STATE OF CONNECTICUT
CONNECTICUT SITING COUNCIL

SBA TOWERS III/NEW CINGULAR
WIRELESS PCS, LLC APPLICATION FOR A
CERTIFICATE OF ENVIRONMENTAL
COMPATIBILITY AND PUBLIC NEED
FOR A TELECOMMUNICATIONS FACILITY
LOCATED AT WEWAKA BROOK ROAD
BRIDGEWATER, CONNECTICUT

DOCKET NO. 412

SBA TOWERS III (“SBA”) AND NEW CINGULAR WIRELESS PCS, LLC (“AT&T”)
RESPONSES TO TOWN OF BRIDGEWATER INTEROGATORIES

REV 0

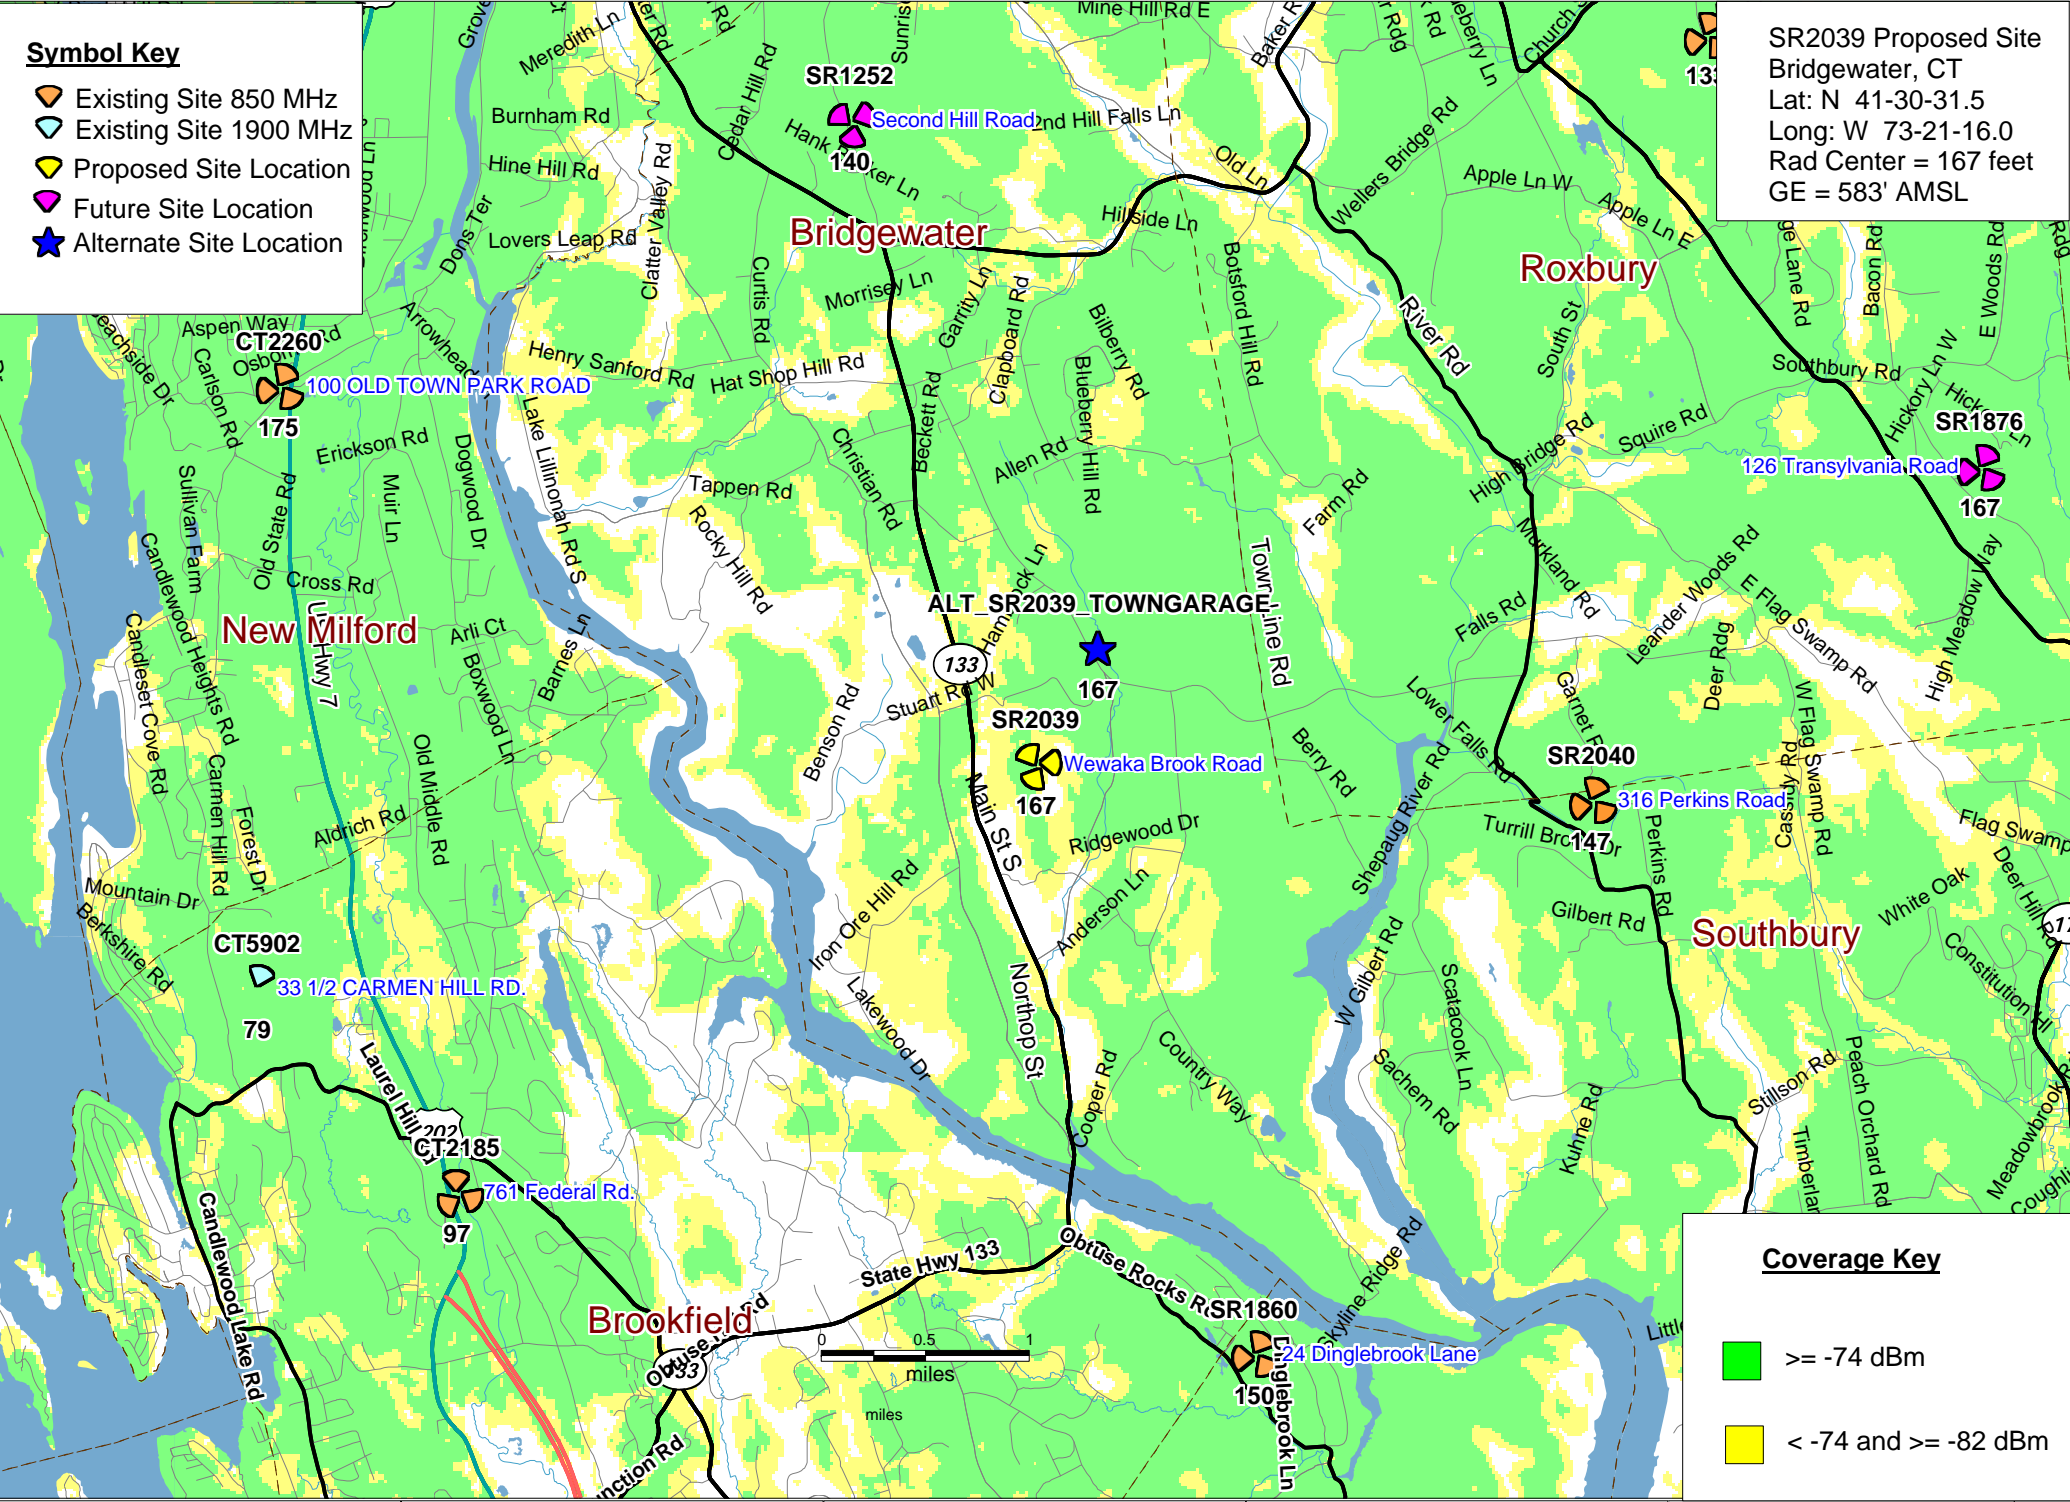
Q8. Has the applicant performed a minimum height analysis to determine the minimum antenna centerline that it requires to meet its alleged coverage needs?

Q37. Can you provide coverage propagation maps and isolated propagation maps for the proposed facility on clear plastic overlays using a scale that matches that of the application at heights 10 through 40 feet lower than that proposed?

A8. Yes. Please see plots included in Attachment 3 which depict coverage at lower heights.

A37. Plastic overlays showing the combined existing and proposed coverage with the proposed site at 10, 20, 30 and 40 feet below the requested height are being provided separately. Attachment 3 provides paper copies of same. Four (4) sets of overlays are being filed with the Siting Council as well.

ATTACHMENT 4

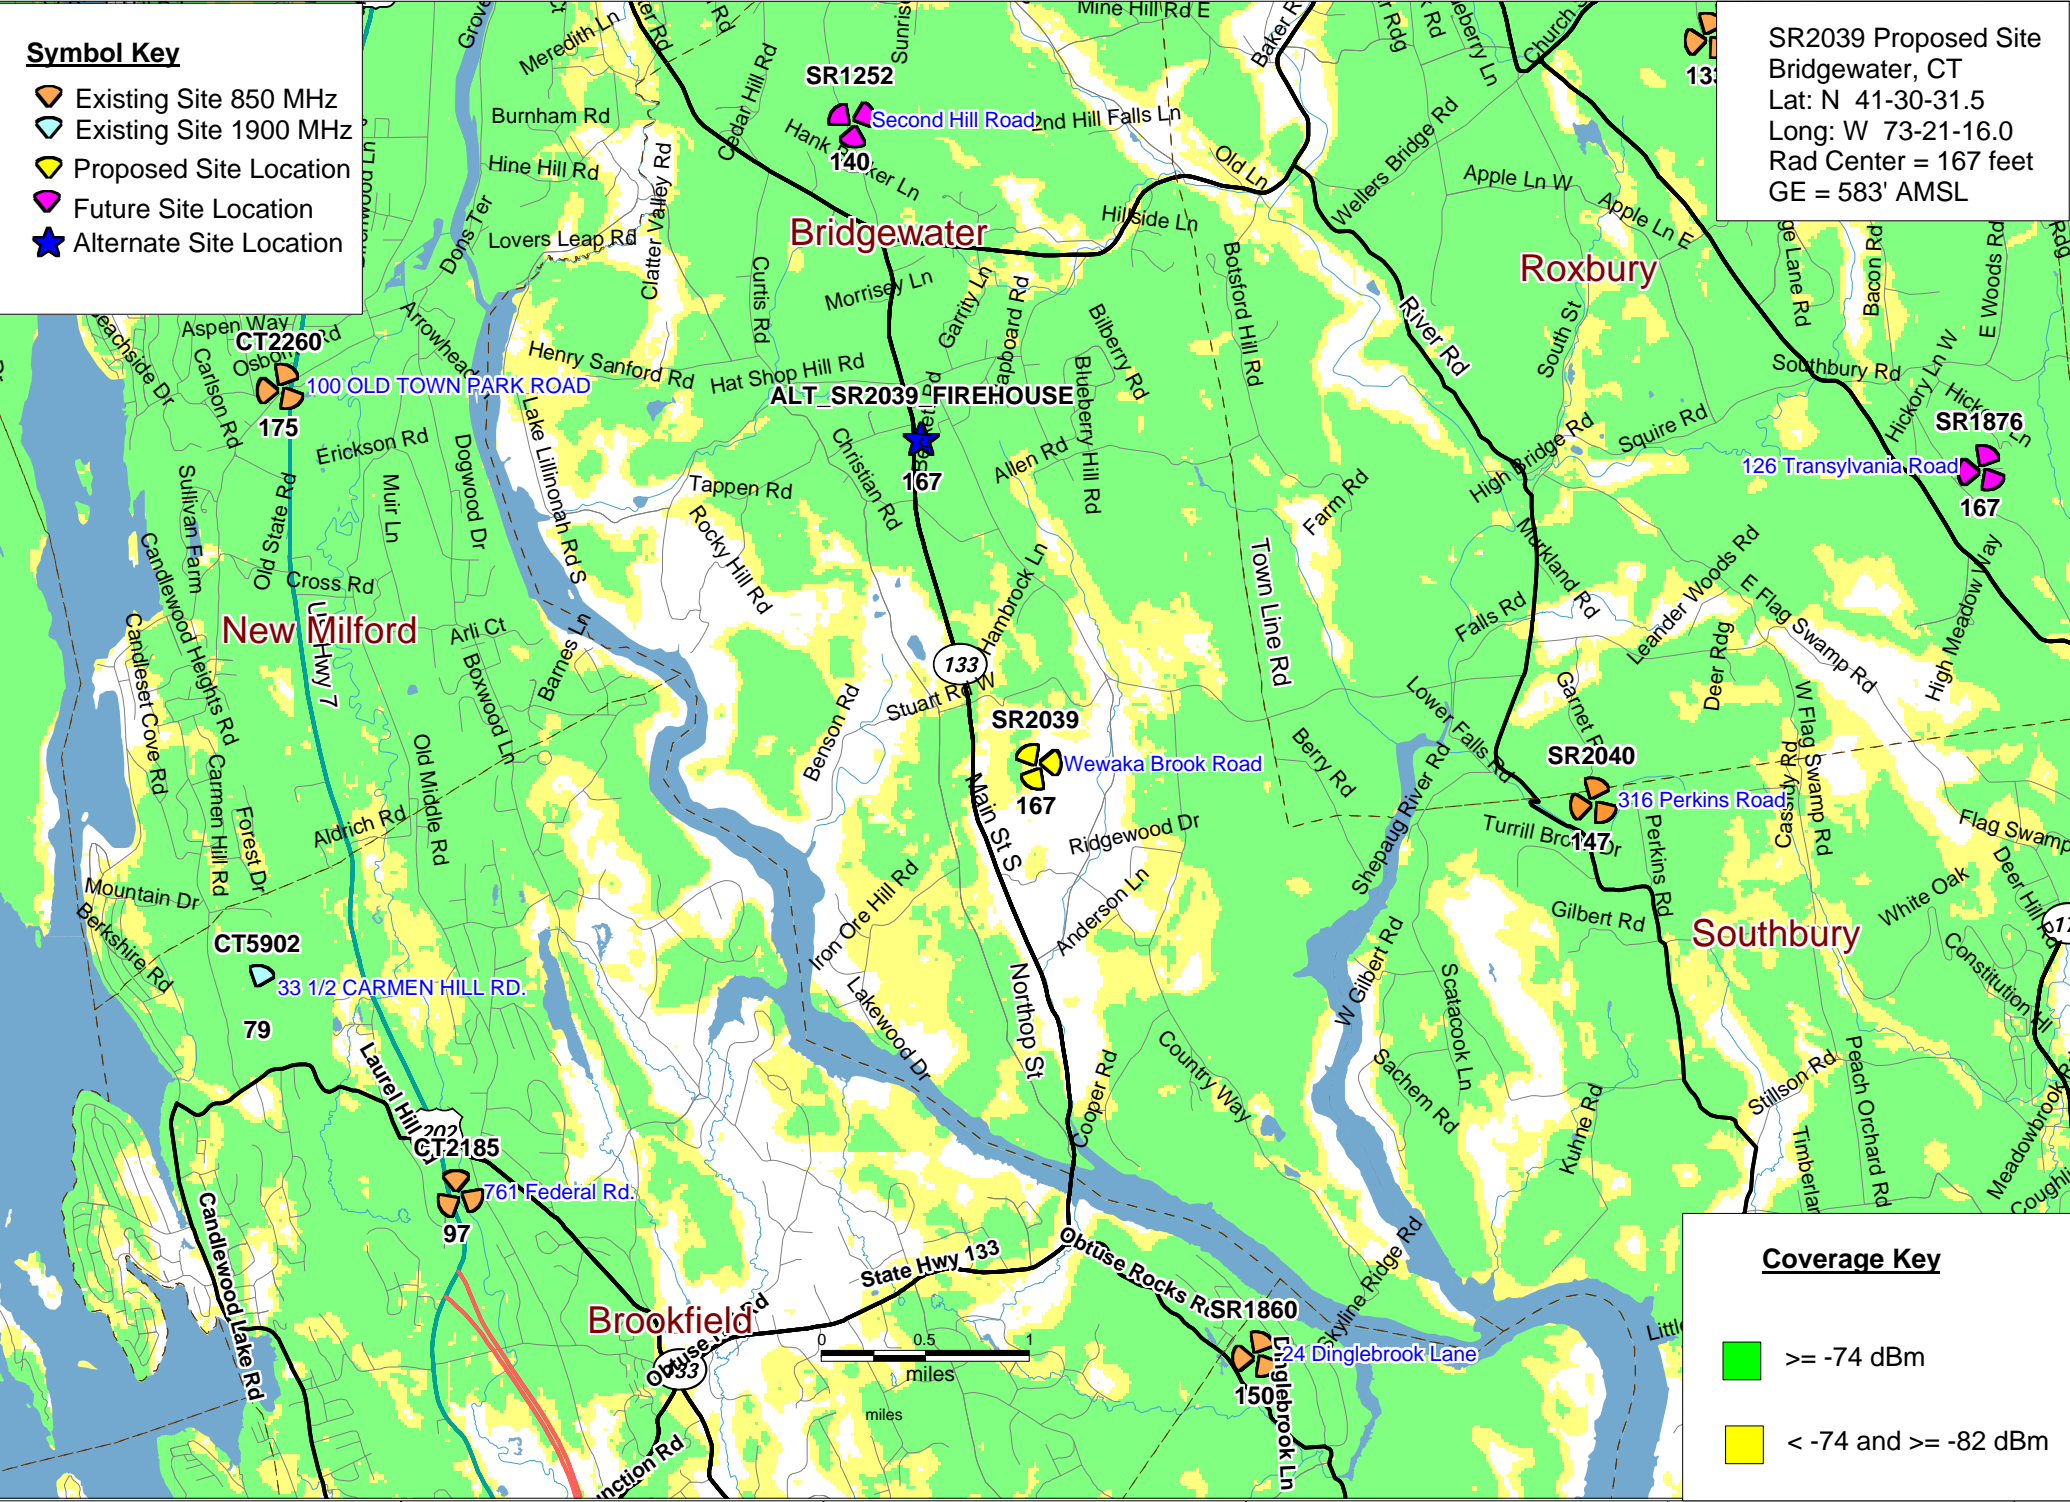
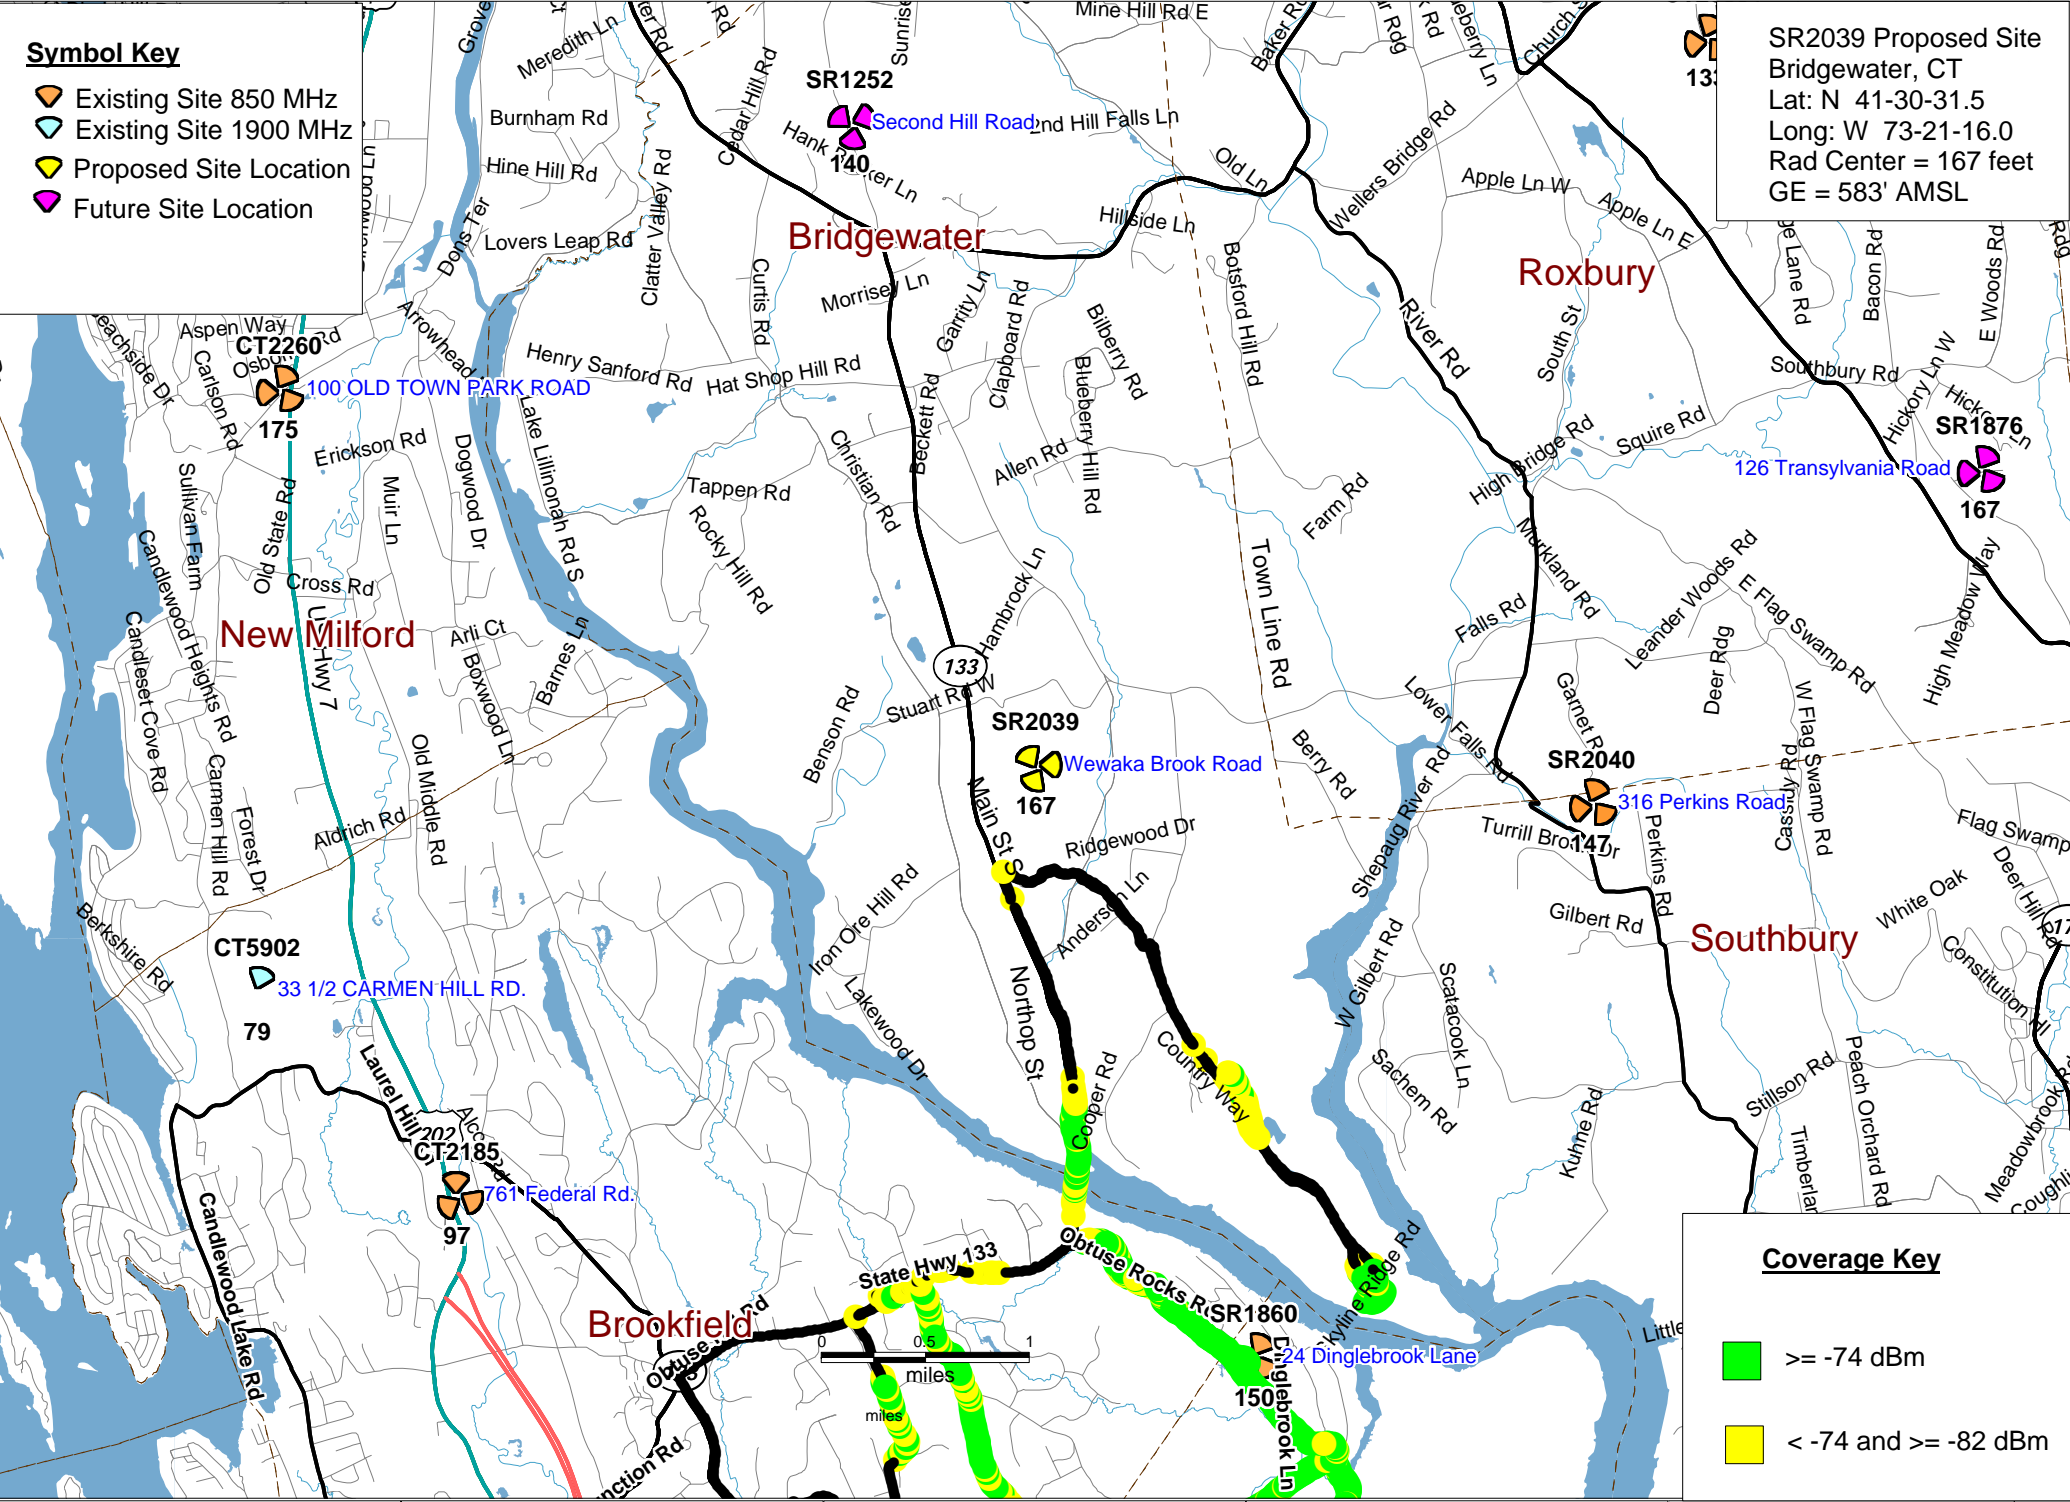
Q9. By what method was it determined that identified alternate sites did not meet the needs of the Applicant? If studies were conducted to confirm the utility of the alternate sites, please provide copies of those studies?

A9. The vast majority of alternatives reviewed were ultimately not available by property owners. In general, however, information regarding potential site locations, including coordinates and elevation, are reviewed by AT&T radio frequency engineers to determine the feasibility of using a given location to provide needed coverage. Sites are evaluated as to their ability in providing coverage to an identified area and to certain coverage objectives including populated areas and roads. Sites must also be made available by willing landlords. No formal studies were produced, though in some cases coverage maps have been produced subsequently. Two sites which were the subject of discussion during the municipal consultation process were the Town Garage and the Fire Department, neither of which would provide reliable service to the south along Route 133. Coverage maps of those alternatives are provided in Attachment 4.
